SUBJECT: NuScale Power, LLC Response to NRC Request for Additional Information No. 222 (eRAI No. 9116) on the NuScale Design Certification Application

NuScale Response to NRC Request for Additional Information eRAI No. 9116

eRAI No.: 9116

Figure 1.2-2: NuScale Functional Boundaries

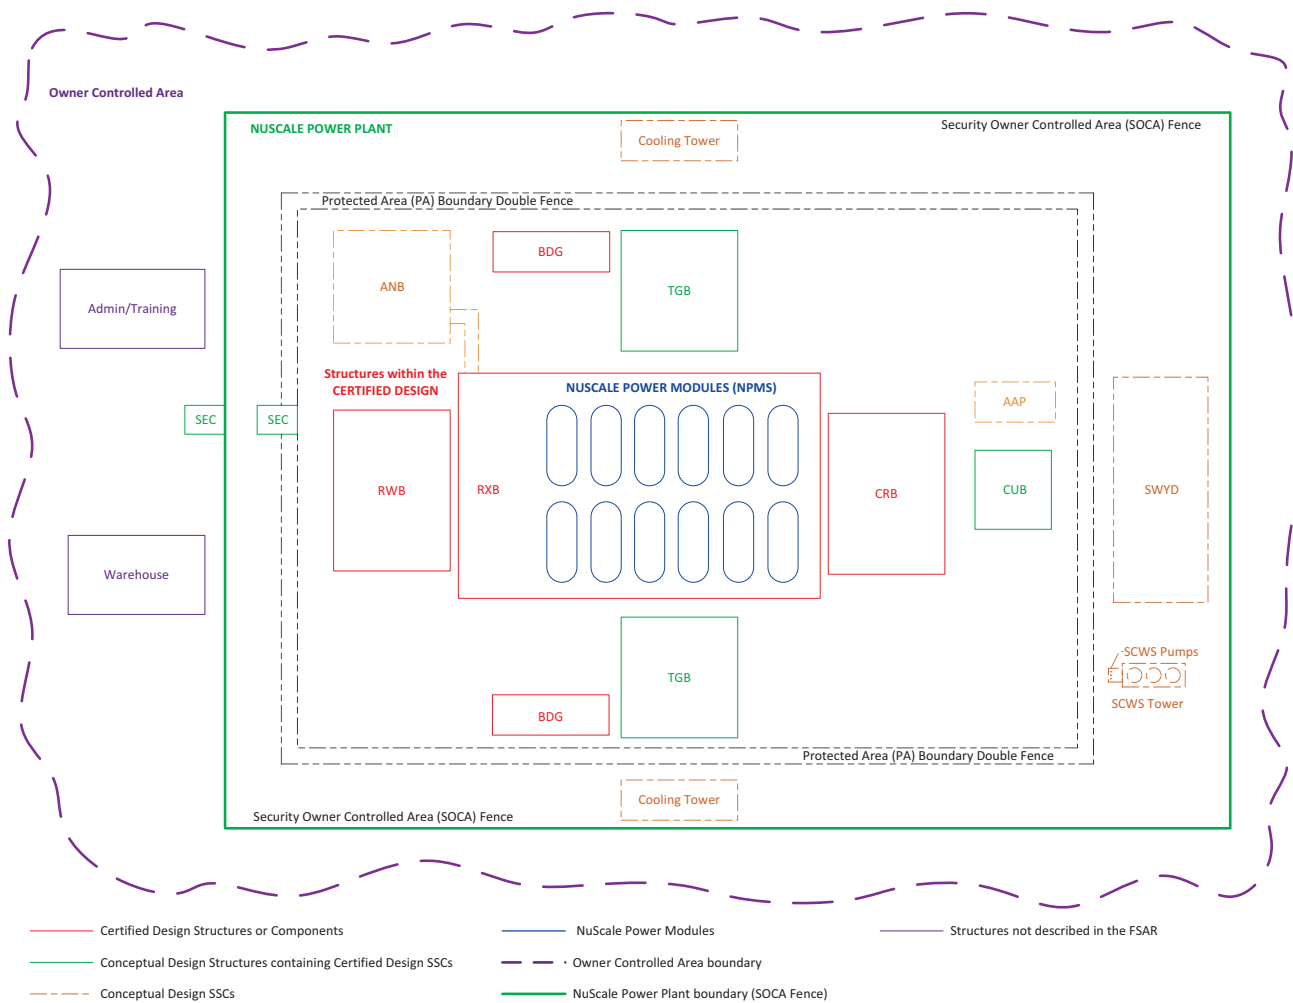
The applicant is requested to provide in the FSAR a description of which portions of the SCWS are part of the design certification and which are considered site-specific or conceptual design information, and appropriately identify the site cooling water tower and pump structure in Figure 1.2-2.

FSAR Section 1.2.1 has been revised to list the SCWS as CDI. FSAR Figure 1.2-2 has been revised to show the proposed location of the SCWS pumps and cooling tower. In addition,

FSAR Figure 1.2-2 has been revised to show the proposed location of the site cooling water system (SCWS) pumps and cooling tower. In addition, FSAR Table 3.2-1 has been revised to show that the location for the SCWS components is “various” instead of “yard.” The location of the SCWS letdown line radiation monitor is still the yard.
